ADDENDUM

ADDENDUM NO.: 03
PROJECT NAME: CDOT – Lincoln Square Brown Line Area Improvements
PROJECT NO.: 22705
CONTRACT NO.: C1612
DATE OF ISSUE: August 15, 2024

NOTICE OF CHANGES, MODIFICATIONS, OR CLARIFICATIONS TO CONTRACT DOCUMENTS

DRAWING NO. **S00-3**
SHEET NO. 8

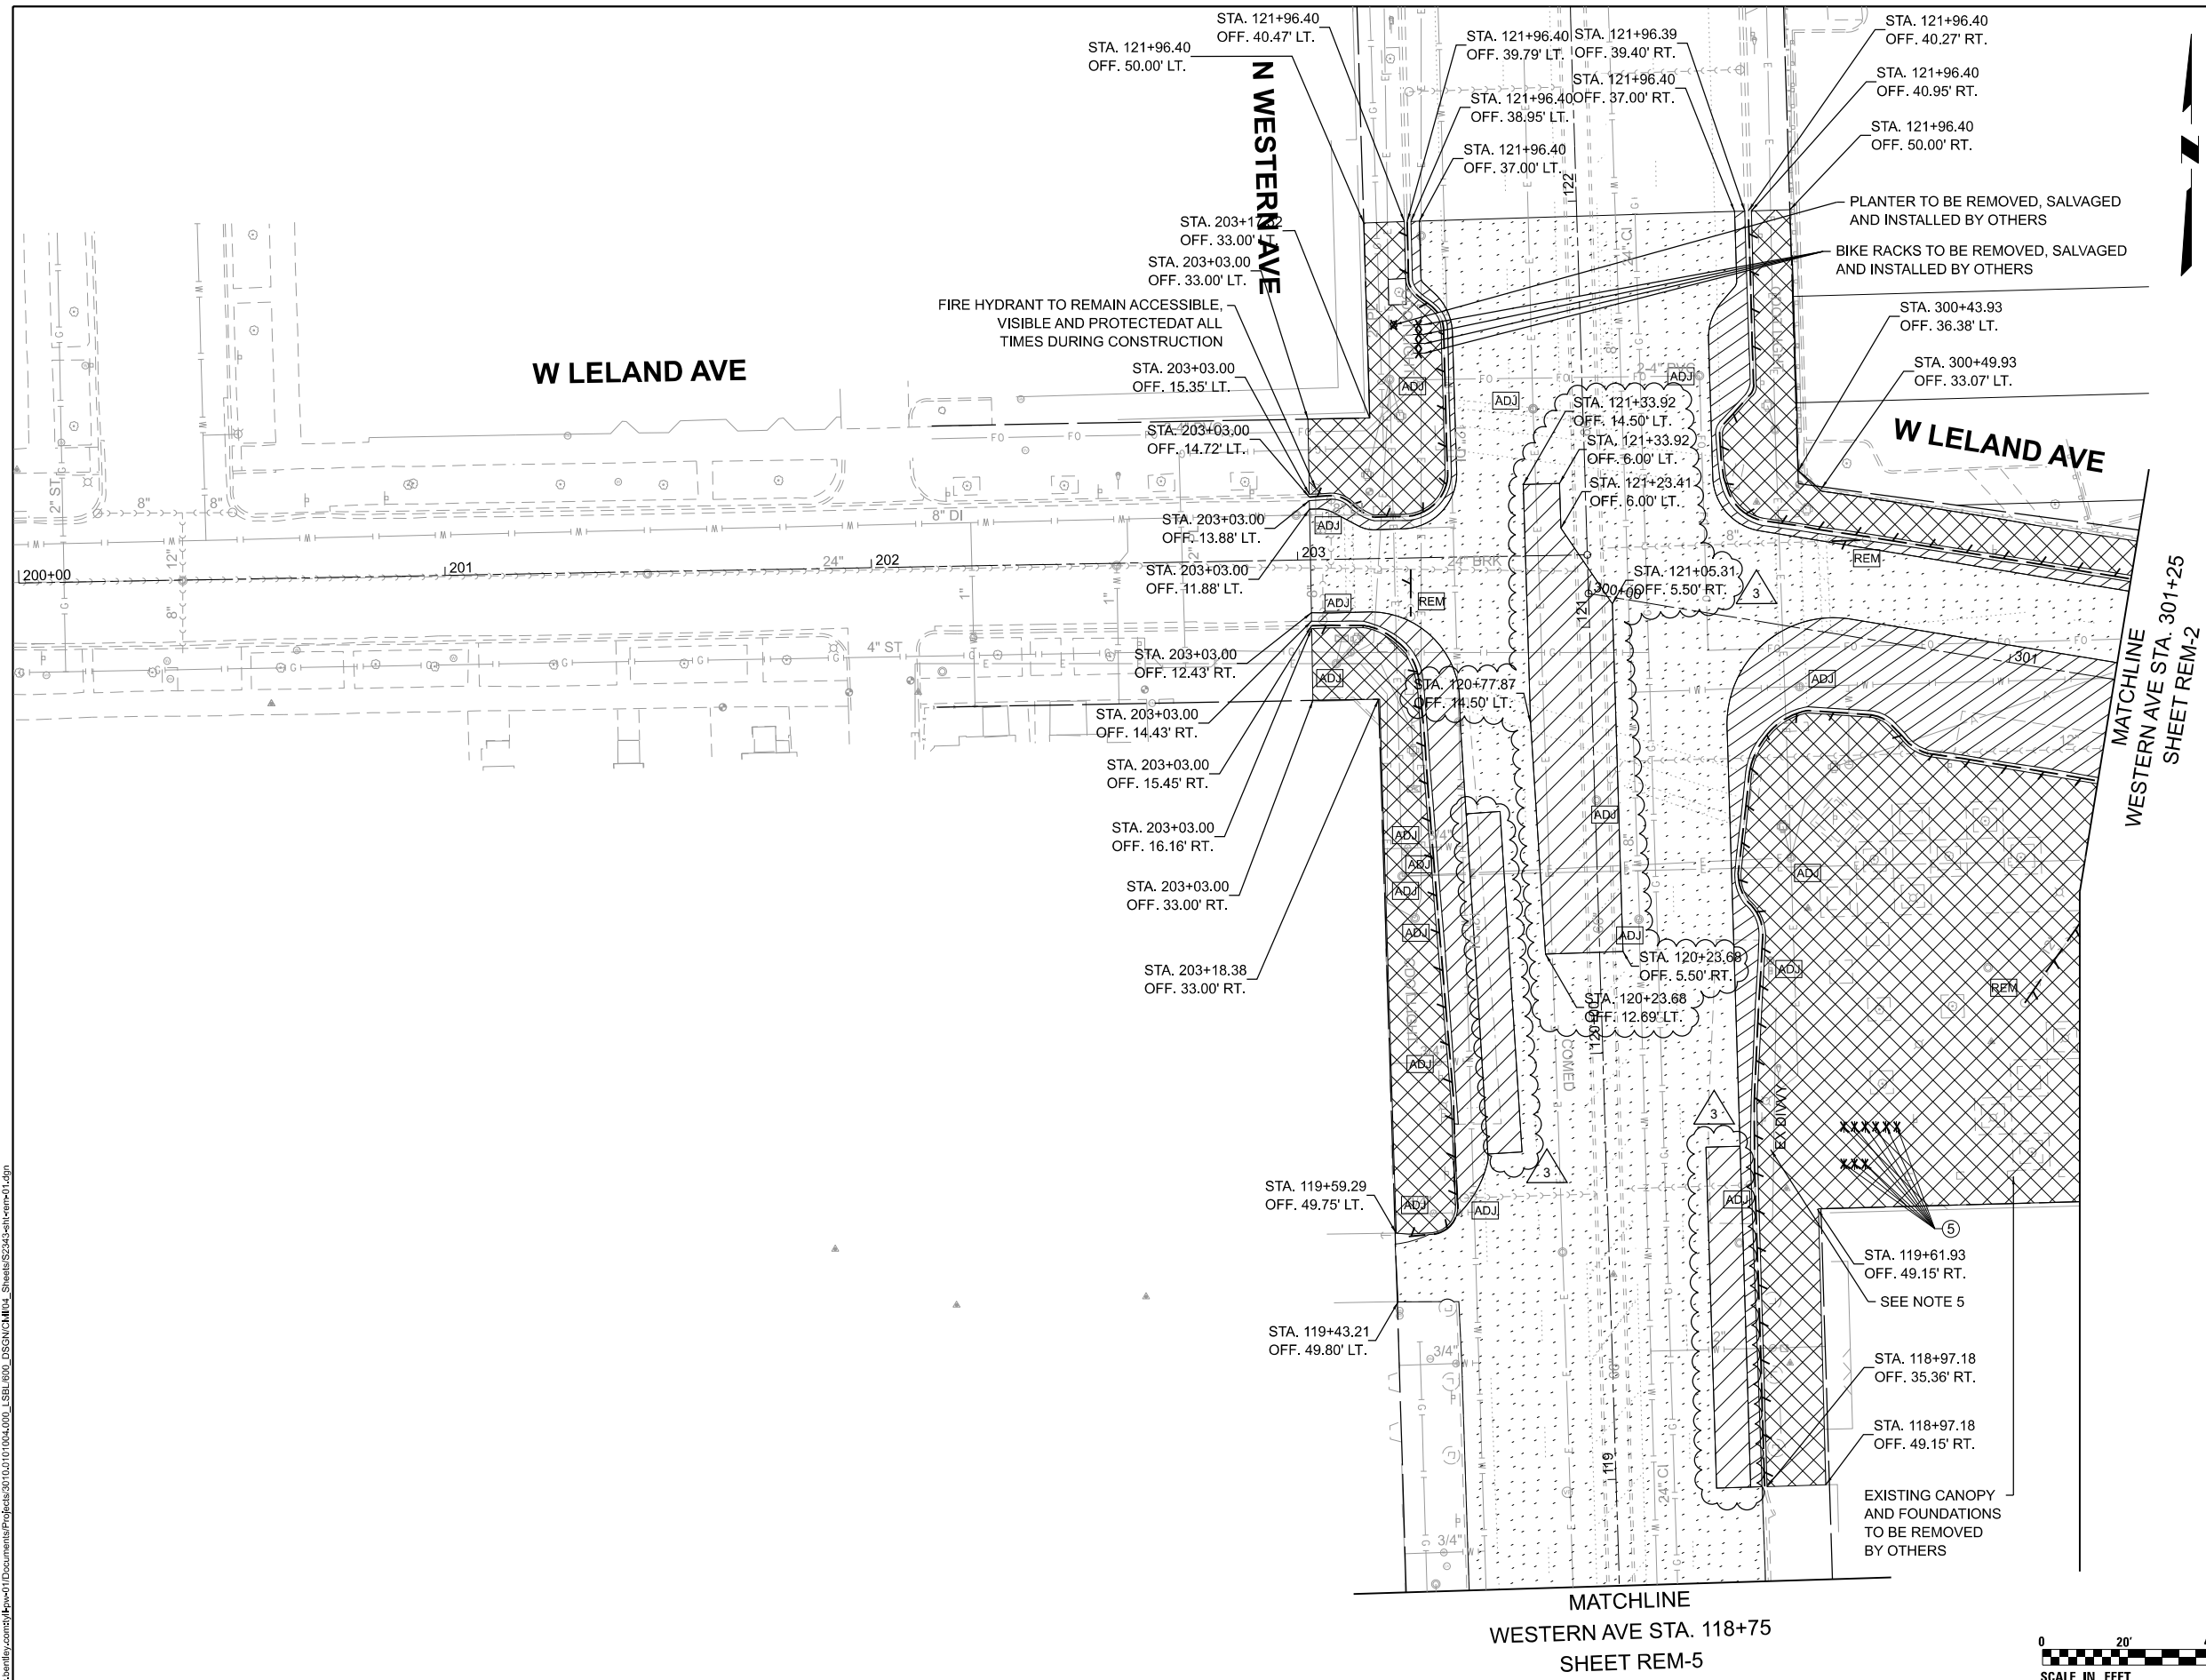
Question: Refer to sheet S00-3. The schedule of quantities shows that there are (5 EA) of Item No. 209 "TRASH RECEPTACLES, SSA." These are not shown in the contract drawings, nor is a detail provided. Please indicate the page where "TRASH RECEPTACLES, SSA" are shown on the contract drawings or revise the summary of quantities to remove Item No. 209 "TRASH RECEPTACLES, SSA."

Question: Refer to sheet S00-3. The schedule of quantities shows that there are (3 EA) of Item No. 208 "TRASH RECEPTACLES." Refer to Sheet SF-1 and SF-2. There are (6 EA) "Litter Receptacles" shown, detailed on sheet SF-16. Please revise the schedule of quantities to reflect the quantities shown in the contract drawings, or indicate if any of the "Litter Receptacles" shown should be counted as "TRASH RECEPTACLES, SSA" (referring to RFI 1).

SCALE: 1"=20'	SHEET OF SHEETS	REMOVAL PLAN LELAND AVENUE	DRAWING NO. REM-1
			SHEET NO. 44

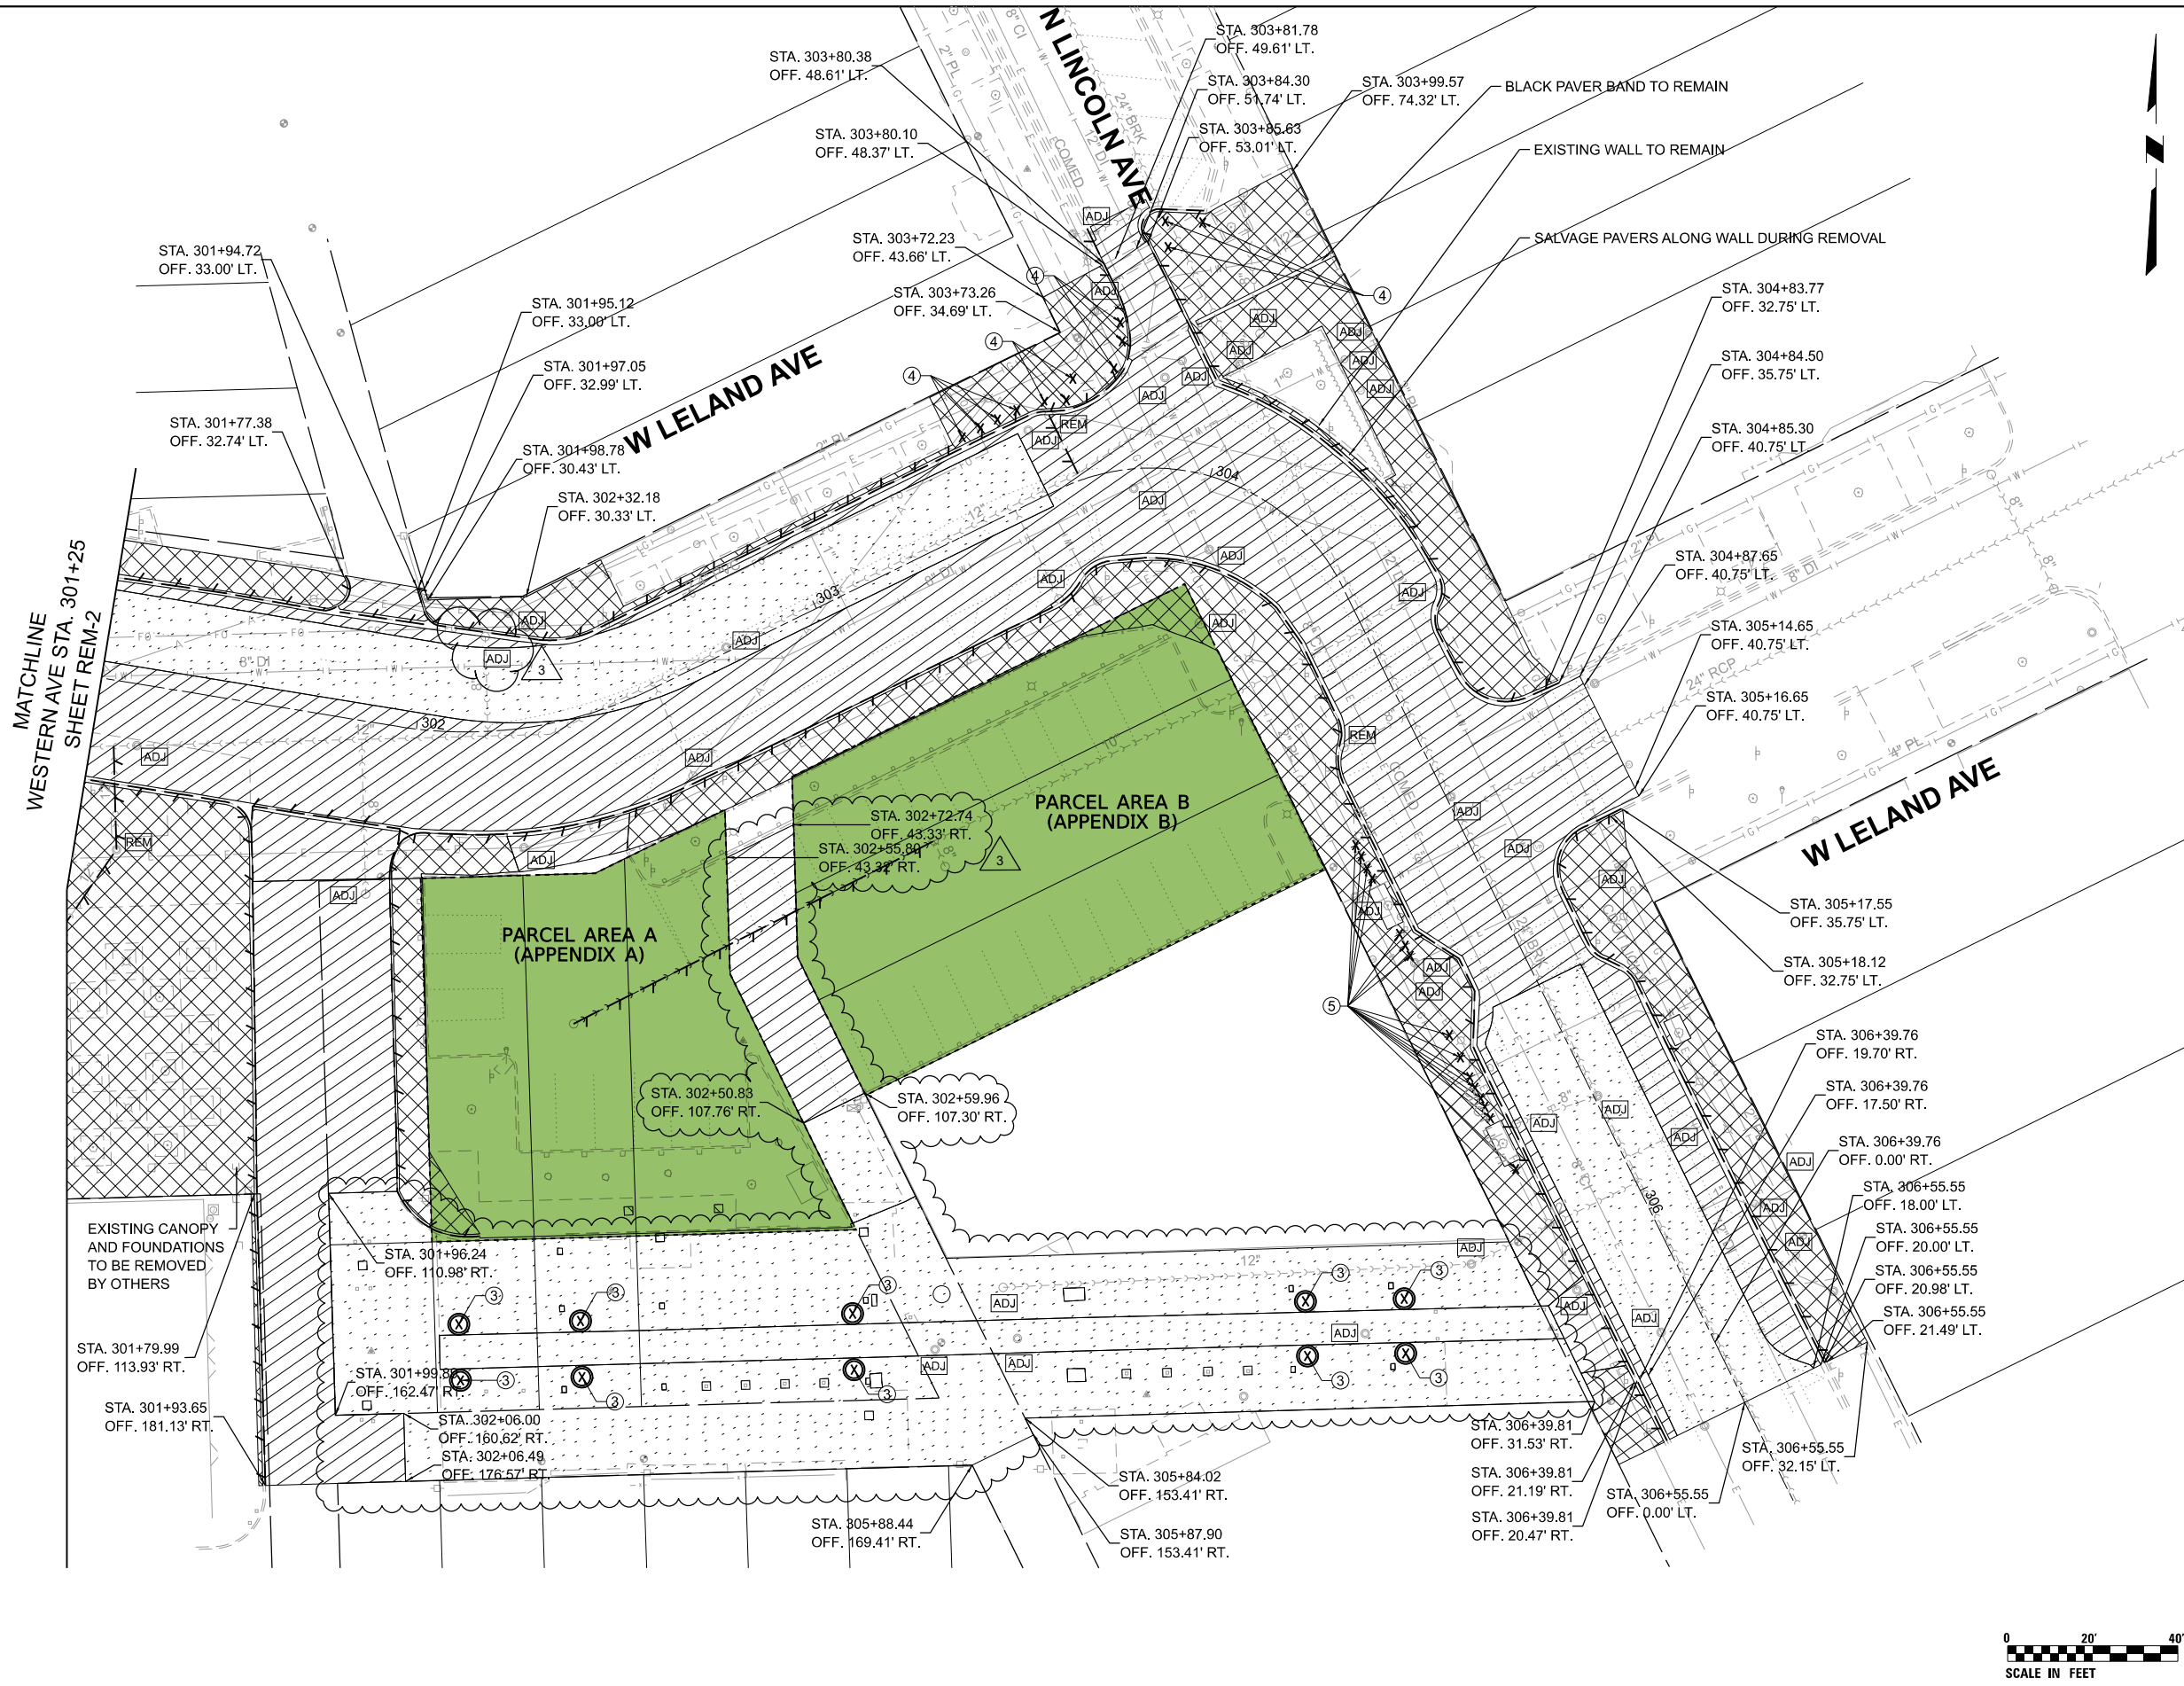
Question: Reference Sheet 44, 45, 49 and 50, the quantities for Hot mix asphalt depth removal variable depth and new asphalt is not accurate to the quantities given. Please correct quantities.

Response: Drawings SOQ-1, REM-1, REM-2, PR-1 and PR-2 for areas related to HMA surface removal, pavement removal and HMA resurfacing have been revised and are included in this addendum.
